DDD-B-166

AMENDMENT—2
APRIL 26, 1940

FEDERAL SPECIFICATION

BELTING; CONVEYOR, NARROW (STITCHED-DUCK)

FIGURE 1.

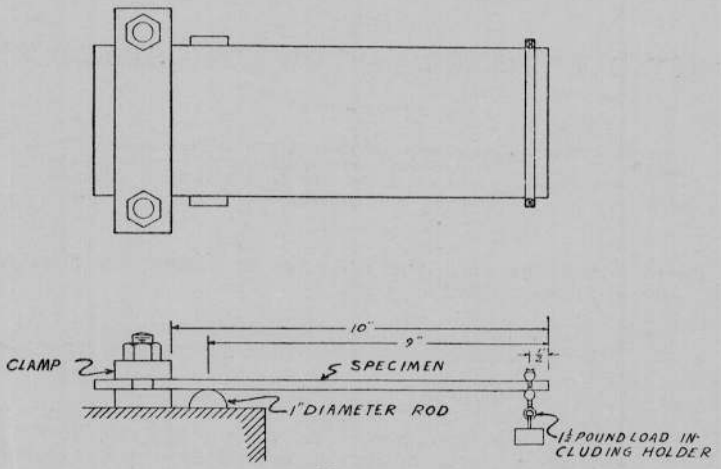
Section **F.** Insert paragraph F–6 as follows:

F–6. *Accelerated aging test.*—A specimen 4 inches wide, plus or minus ⅛ inch, and 12 inches long, plus or minus ¼ inch, with the long dimension parallel to the lengthwise direction of the belt, is cut at a distance of not less than 3

inches from either edge. It shall be free from seams and splices. The specimen shall be suspended in circulating air at a temperature of 100° C., plus or minus 3° C., for a period of 14 days. At the end of this period, it is placed between 2 flat boards, sufficient weight is placed on the top board to hold the specimen parallel to the surfaces of the boards, and it is maintained in this position for 4 hours. A reference mark is placed in the test piece at ½ inch, 9 inches, and 10 inches, plus or minus ⅛ inch, respectively, from the same end of the specimen and at right angles to its long dimension. The specimen is conditioned for at least 16 hours at a temperature of 70 to 75° F. It is then immediately clamped tightly at the 10 inch mark and supported on a 1 inch, plus or minus ⅛ inch, diameter rod at the 9 inch mark. The clamps and rod shall extend across the full width of the

test piece and its faces shall be horizontal within a tolerance of ¼ inch. A load of 1½ pounds, plus or minus $\frac{1}{16}$ pound, is applied at the ½ inch mark uniformly across the width of the specimen for 5 minutes, and the vertical deflection of the end of the specimen is measured. The specimen is maintained at a temperature of 70 to 75° F. from the time of its removal from the heated air until the deflection is measured. (See Fig. 1).
